MONTGOMERY COUNTY HISTORIC PRESERVATION COMMISSION
STAFF REPORT

Address:	23 Hesketh Street, Chevy Chase	Meeting Date:	3/25/2026
Resource:	Contributing Resource Chevy Chase Village Historic District	Report Date:	3/18/2026
Applicant:	Susie and John Lively (Thomas Hazzard, Agent)	Public Notice:	3/11/2026
Review:	HAWP	Tax Credit:	No
Permit No.:	1150981	Staff:	Laura DiPasquale
Proposal:	Partial demolition and construction of front portico

Figure 3: Side and front elevation views of the proposed portico and landing.

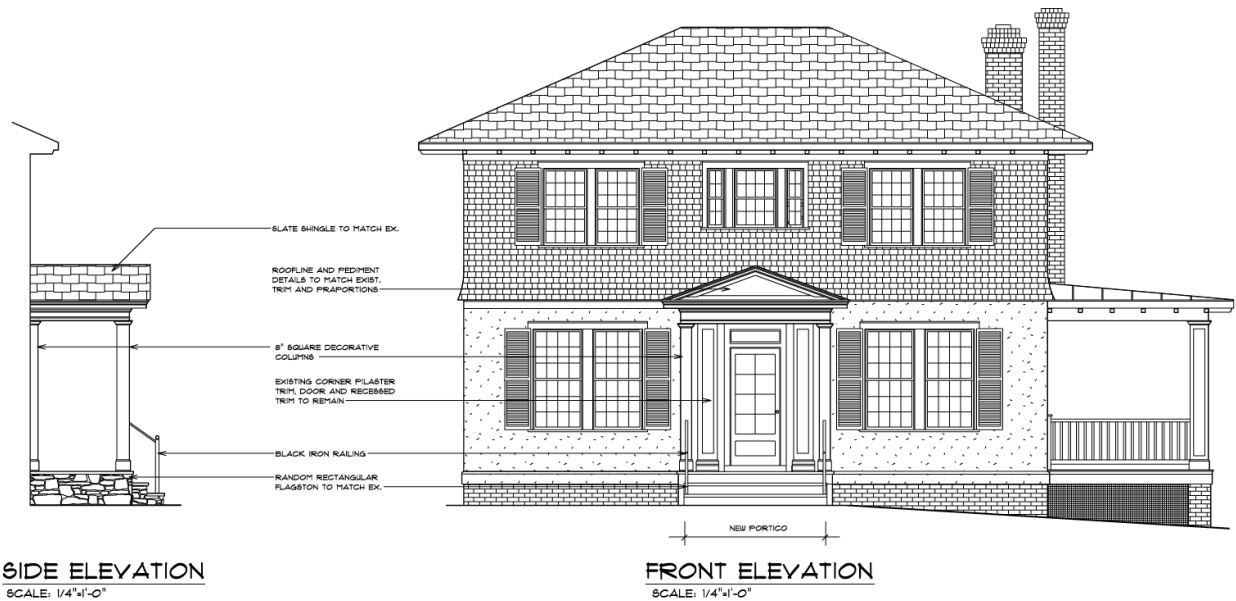
Staff finds that, per the *Guidelines*, the alteration/removal of portions of the front door trim and construction of a front “porch” or portico should both be reviewed with moderate scrutiny. Staff finds that the proposal partially complies with *Standards 2 and 9*, as it involves the removal of some historic materials, which runs counter to the *Standards*, but that the design of the proposed portico is compatible with the style and character of the resource and retains the overall character of the property, per the *Standards, Guidelines*, and Chapter 24A-8(b)(2). Staff finds that the addition of pilasters flanking the existing pilasters allows the proposed portico structure to be more or less freestanding, with limited intrusion into the historic fabric for structural purposes. Staff finds that the simpler proposed pilaster and column design is also compatible with, but differentiated from, the more elaborate historic trim and that the wider spacing will provide views of the historic trim and from the public right-of-way. Staff notes that the drawings state that the roofline and pediment details will match the existing trim and proportions, but that no section cuts have been provided for those details. Staff notes that the application also does not specify the material of the proposed posts, and recommends that the HPC condition an approval on submission of detail drawings including section cut(s) through the pediment documenting the raking and horizontal cornice profiles and depth of the tympanum to be replicated in the new construction, and that all new posts, pilasters, and trim be painted wood.

1. The applicant must provide detail drawings including section cut(s) through the pediment documenting the raking and horizontal cornice profiles and depth of the tympanum to be replicated in the new construction.
2. The portico posts, pilasters, and all trim must be painted wood.

Figure 5: Existing and proposed pilaster trim details.

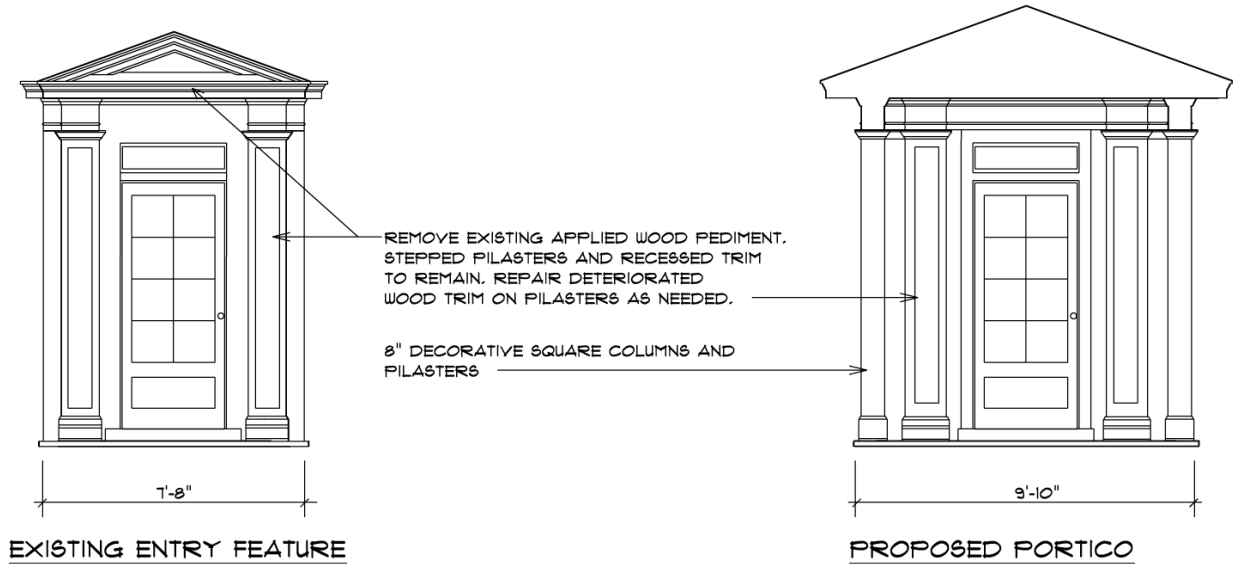
Staff notes that elaborate door surrounds, in the form of the flatter pilasters topped with decorative moldings or pediments (such as the one currently found on the subject property), and as projecting porticos, (such as the proposed design), were frequently incorporated into early 20th-century revival styles such as those found throughout Chevy Chase (see *Figure 6, Figure 7, and Figure 8*). As such, staff finds that the proposed work will be compatible with the character of the resource and district, and allowable under a standard of moderate scrutiny standard in Chevy Chase Village and Chapter 24A-8(b)(1).

Tree Preservation Plan – 23 Hesketh Street

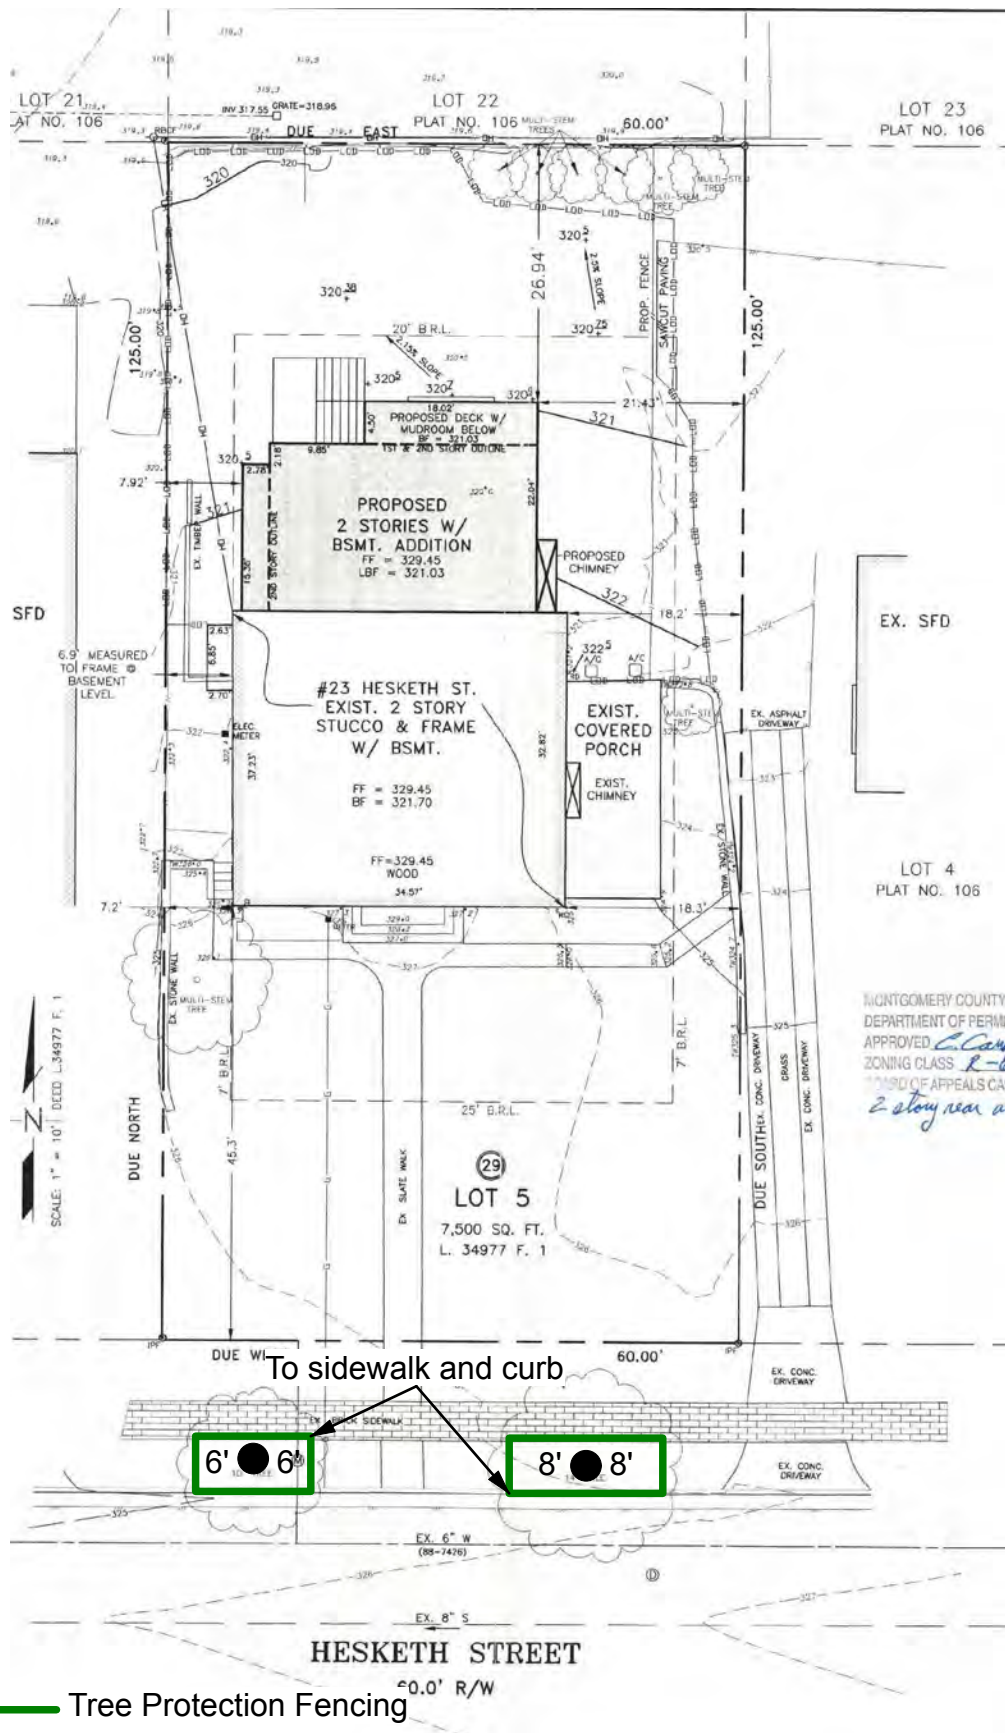
1. Tree preservation fencing shall be installed in the locations shown on the plan. The street tree shall be protected. Tree preservation fencing shall delineate the tree protection zones. Tree preservation fencing shall be 4' tall wire mesh supported with steel stakes no less than 8' apart.

2. The Owner/Contractor shall inform all on-site workers that the tree preservation zones shall not be entered. Neither materials nor equipment shall be stored within the tree preservation zones. No grading shall be done within the tree preservation zones. The grading outside the tree preservation zones shall not be changed to divert and collect water within tree preservation zones.

3. No excavation is permitted within the tree preservation areas.
4. The Chevy Chase Village office shall be notified of any construction plan changes.
5. If excavation (outside the tree preservation zone) exposes roots on protected trees, the damaged roots shall be cleanly cut before backfilling the hole.

6. The Owner/Contractor shall maintain the fencing until the construction is complete. The fencing may be removed to prepare and install the new landscaping.
